March 20, 2014

Re: Office of Engineering and Technology Seeks to Supplement the Incentive Auction Proceeding Record Regarding Potential Interference Between Broadcast Television and Wireless Service, ET Docket No. 14-14; In the Matter of Expanding the Economic and Innovation Opportunities of Spectrum Through Incentive Auctions, GN Docket No. 12-268

**COMMENTS OF THE  
NATIONAL ASSOCIATION OF BROADCASTERS, ABC TELEVISION AFFILIATES  
ASSOCIATION, FBC TELEVISION AFFILIATES ASSOCIATION, CBS TELEVISION  
NETWORK AFFILIATES ASSOCIATION, NBC TELEVISION AFFILIATES, THE  
ASSOCIATION OF PUBLIC TELEVISION STATIONS, THE CORPORATION FOR  
PUBLIC BROADCASTING, AND THE PUBLIC BROADCASTING SERVICE**

Figure 1.

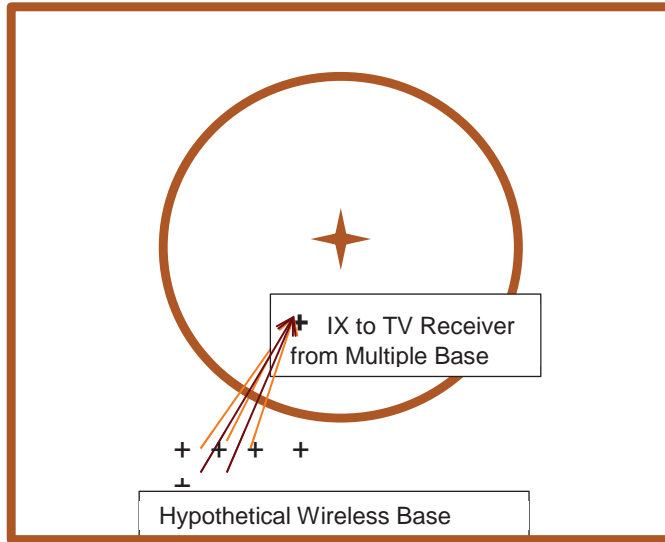
In reality, wireless providers are likely to have a large number of cell sites in close proximity operating over a wide area with high traffic volumes at multiple base stations at the same time. Transmissions from multiple base stations can combine and cause interference to DTV service, even in cases where a single wireless signal may not cause interference.

This signal combining interference phenomena is well understood. In fact, the recently established rules governing Digital Television Distributed Transmission Systems (“DTS”) address this issue.<sup>39</sup> DTS employ multiple synchronized transmitters spread around a DTV station’s service area similar to a wireless cellular network architecture. To ensure that DTS transmissions do not interfere with DTV reception, the rules provide that the *combined* effect of all DTS transmitters must be taken into account in interference calculations. Specifically, the Commission requires that the root-sum-square (RSS) method of calculating interference from multiple DTS transmitters must be used to calculate both adjacent channel and co-channel interference.<sup>40</sup>

proposed OET methodology, a DTV receiver receiving a 65 dB $\mu$  DTV signal and two 50 dB $\mu$  interfering signals from two proximate co-channel wireless sites would be deemed to have no interference since each wireless base station would meet the 15 dB D/U ratio (for each transmitter,  $D/U = 65 \text{ dB}\mu - 50 \text{ dB}\mu = +15 \text{ dB}$ ). However, these interfering signals will have an additive effect and create interference when combined. Using the RSS method, the two 50 dB $\mu$  signals would result in 3 dB of additional interference at the DTV receiver or a D/U ratio of +12 dB rather than +15 dB. A D/U ratio of 12 dB would result in loss of service at that location.

As the Commission already found with multiple DTS transmitters, the combined interference effect of multiple transmitters needs to be taken into account and “the RSS method in virtually all situations will best approximate actual interference” from multiple transmitters to DTV signals.<sup>41</sup> Failure to consider the combined interference effect of multiple wireless base stations will result in increased interference to DTV stations. The Commission has a statutory responsibility to protect broadcasting and DTV viewers and cannot ignore “real world” interference from multiple wireless operations; thus, any methodology used to predict potential inter-service interference should take this into account. The Joint Broadcasters urge the Commission to consider interference from multiple wireless base stations using either a simple direct summation method or the RSS method utilized for calculating interference from multiple DTS transmitters under the current rules.

**G. An Approach Based on Separation Distance Is Not Overly Conservative or Spectrally Inefficient.**

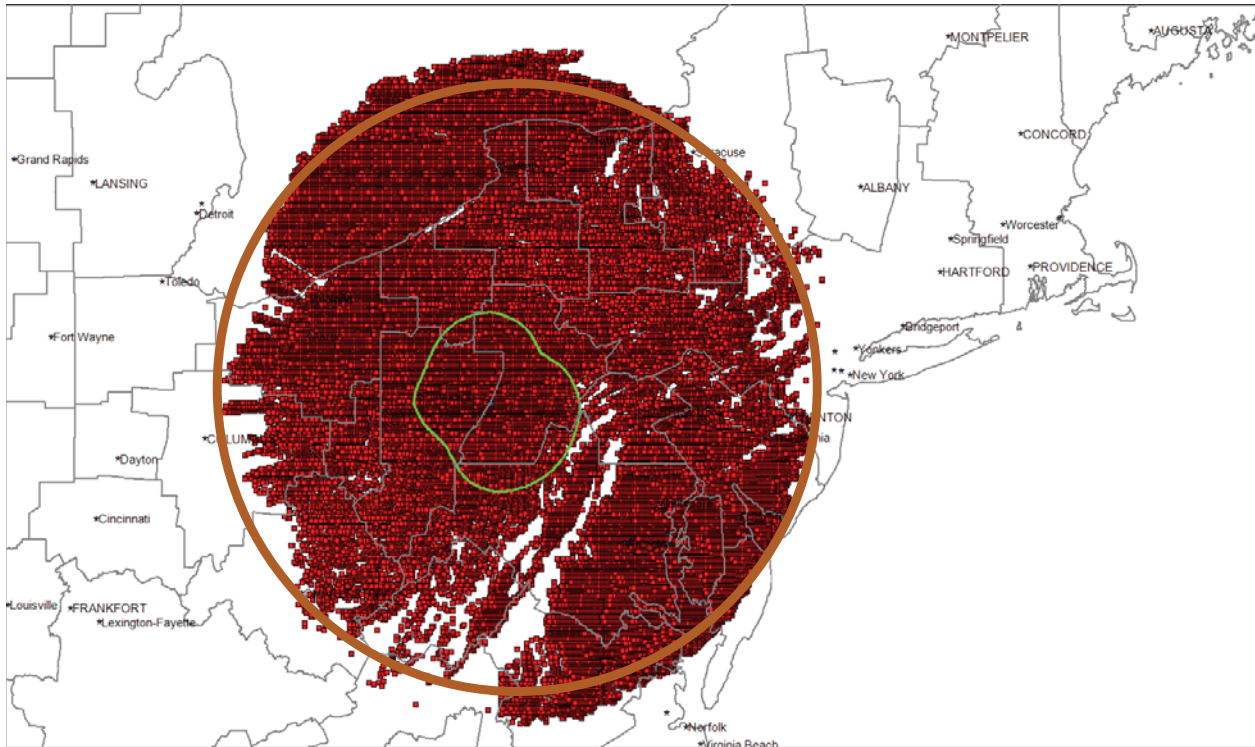
OET suggests that prescribing pre-defined separation distances, as proposed by commenters addressing the issue of co- or adjacent-channel interference, may be spectrally inefficient and overly conservative, and would effectively lump together all interference cases and apply separation distances based on a worst case scenario.<sup>68</sup> In fact, in its submissions on this issue, NAB did not “lump together” the interference scenarios, nor did it provide a “worst case” analysis. Rather, NAB provided a range of separation values and specifically noted that these distances are affected by the technical characteristics of the stations involved, such as transmitting height and power of DTV stations and wireless base stations.

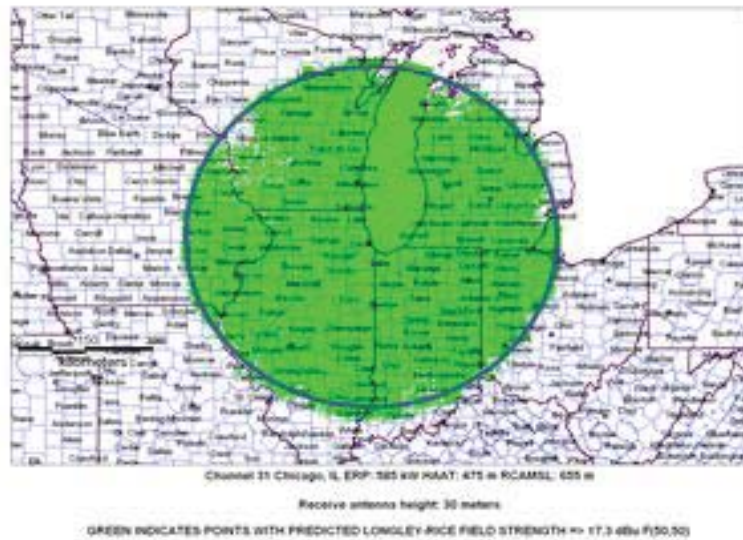
The following plot was shown at the Commission’s February 21 LEARN Workshop regarding the proposed OET methodology. The plot represents the potential for interference from a DTV station to a wireless base station. The station used in this plot is a DTV station in Johnstown, Pennsylvania. Presumably, this DTV station was selected because the irregular terrain in this part of the country would emphasize the difference between using the proposed OET methodology and a simple separation distance or contour. However, *even in this highly irregular terrain*, the practical difference between methods is minimal with respect to spectral efficiency. The contour was added to the LEARN Workshop slide to show what a typical separation distance or contour approach would look like.

To the extent that certain “white spaces” are present within the contour, these generally represent mountain ranges with little or no population to be served. They certainly do not represent areas where widespread wireless deployment is possible or would be anticipated.

To further illustrate this point, we applied the same methodology described in the LEARN workshop to plot another station where the terrain is not a factor in determining potential for interference from a DTV stations to a wireless base station. The station used in the plot below is located in Chicago, Illinois, and has approximately the same technical parameters as the Johnstown, Pennsylvania station. It was chosen because the terrain in this part of the country is essentially flat. It should also be noted that in this case the blue contour has approximately the same radius as the Johnstown station.

These two examples suggest that a straightforward contour calculation does not produce meaningful inefficiencies as compared to the unduly complex and computationally intensive OET methodology. Contrary to OET’s assertions, a separation distance approach is not spectrally inefficient in any meaningful sense, and the proposed methodology will not produce significant additional spectrum. The proposed OET methodology should be abandoned and replaced with a simple contour separation distance approach, discussed in Section VI below. The Joint Broadcasters also believe that providing wireless bidders with simple information such as actual separation distances to co- and adjacent-channel DTV stations is significantly more meaningful than providing bidders with misinformation regarding “impaired” or “restricted” areas based on complex calculations that use erroneous assumptions and assume unlikely hypothetical base station locations.
